Town of Parker Community Development Department
 Development Review Division
 Attention: ~~Krista Flynt~~ **BrieAnna Simon**

Application Type: **Site Plan**
 Status: **First Referral**
 Application Name: **Douglas 234 F1 L1 B10 – Daycare Facility**
 Case/AP#: **SP20-058**
 Referral Received: November 06, 2020
 Comments Due: December 9, 2020

Review date: **November 10, 2020**
 Plan reviewer: **Randall L. Capra, rcapra@parkeronline.org**
 Phone: 303.805.3169

TOWN OF PARKER FIRE/LIFE SAFETY:	R REVIEWED FOR CODE COMPLIANCE; REVISIONS REQUIRED
---	---

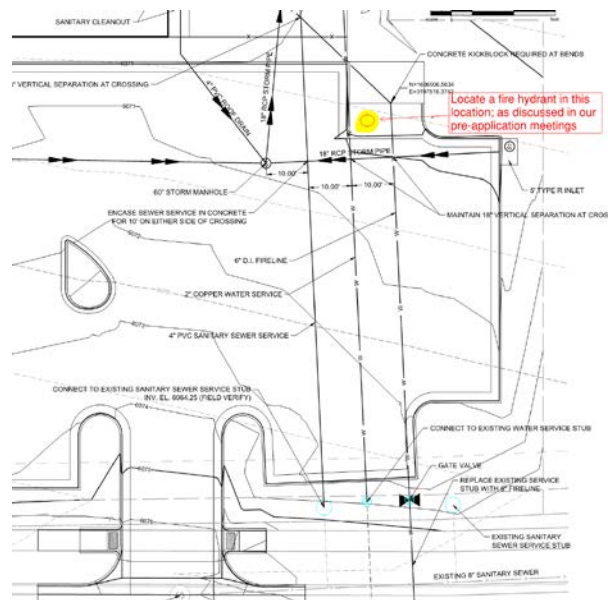
2. The applicant shall be aware that the access road hydrant distribution was not planned to address the suppression needs for all commercial properties within this subdivision; this site requires the addition of one hydrant (to be located at the s/w corner island of the building... as required per NFPA 24 Section 7.2.3... see the snap shot of the red-lined fire hydrant location shown under item 4 below: *Partially satisfied; the applicant has added the hydrant but has stubbed off of the UFL. The fire hydrant is required to tap directly into the water main (see number 4 below for more). Address this issue when resubmitting. Partially satisfied; the fire hydrant has been added and is no longer sharing the line with the required underground fire line. The applicant, however, has the domestic coming off the fire line, now. Remove the domestic from the fire line... providing a fire line that does not share the line with other lines. Address this issue when resubmitting. Satisfied; applicant has addressed/acknowledged with current submittal.*

4. As discussed in each pre-application meeting, the applicant will need to provide interior to this site; the applicant shall provide a fire hydrant in the area just southwest of the southwest corner of the building, see below: *Not satisfied; while the applicant has added the fire hydrant, the fire hydrant and the fire line must be their own separate lines (this way, if you lose one line you don't lose the other). Resubmit addressing this issue. Note – the UFL must also show the length... as measured from the "T" at the water main to the flange in the building. Not satisfied; while the fire line has been separated from the fire hydrant, the domestic has been tied into the fire line. The fire line is that section of pipe that runs from the building to the "T" in the road. Identify the length from the "T" to the flange and remove the domestic from the fire line. Satisfied; applicant has addressed/acknowledged with current submittal.*

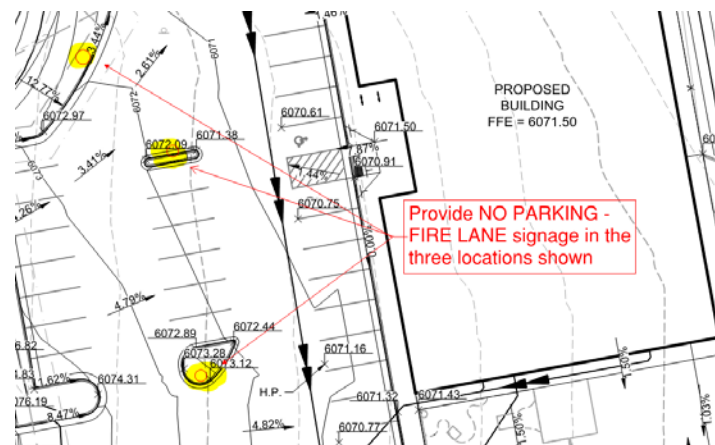
6. The applicant shall, in addition to notating that the UFL is a 6:" line, notate the length of the UFL as measured from the "T" on the street to the flange in the building. Address this issue when resubmitting. *Not satisfied; the applicant did not address this comment when resubmitting. Not satisfied; while the fire line has been separated from the fire hydrant, the domestic has been tied into the fire line. The fire line is that section of pipe that runs from the building to the "T" in the road. Identify the length from the "T" to the flange and remove the domestic from the fire line. Partially satisfied; applicant has addressed/acknowledged with current submittal though the applicant has not notated the length and size of the UFL on the overall utility sheets. Prior to submitting for signatures, update the plan set to address this issue. Note – The submittal indicates that the irrigation line is to be lowered to clear fire line... the applicant shall be aware that a minimum of 18" of clearance is required above/below the fire line when intersecting other utilities; the fire line is not allowed to have a joint where intersecting lines occur. Satisfied; applicant has addressed/acknowledged with current submittal.*

FIRE CODE REVIEW BLOCK

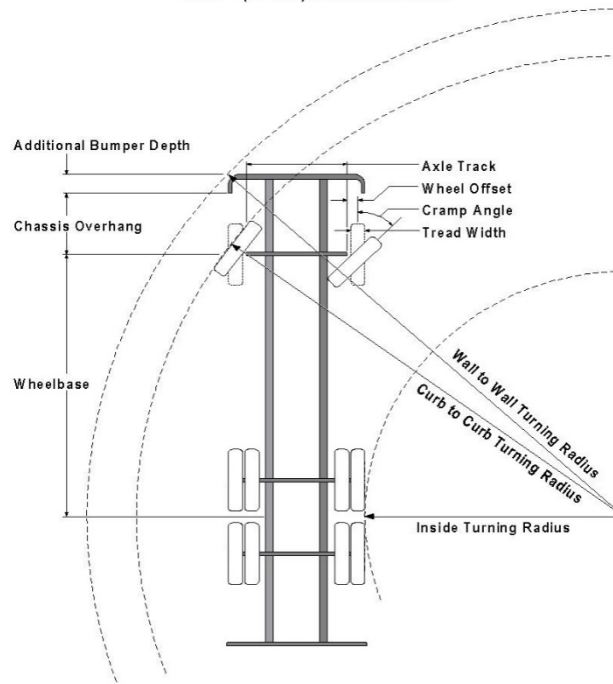
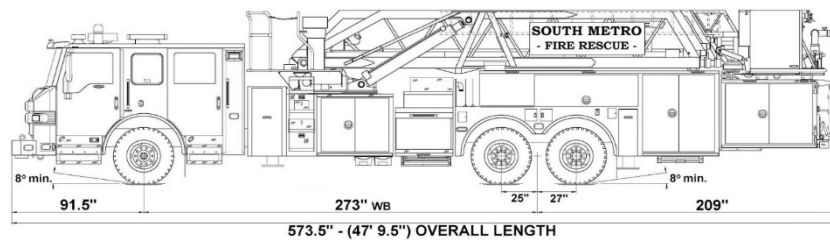
5. The applicant has not provided a signature block for Fire Life Safety on the utility plan set that has been authorized for use by this office; ensure that the correct FIRE LIFE SAFETY review block is used for both the cover page and the overall utility plan. A copy of this stamp can be found later on in this document; address this issue when resubmitting. *Not satisfied; the applicant shall add a signature block for Fire Life Safety to the Overall Utility Plan. Satisfied; applicant has addressed/acknowledged with current submittal.*
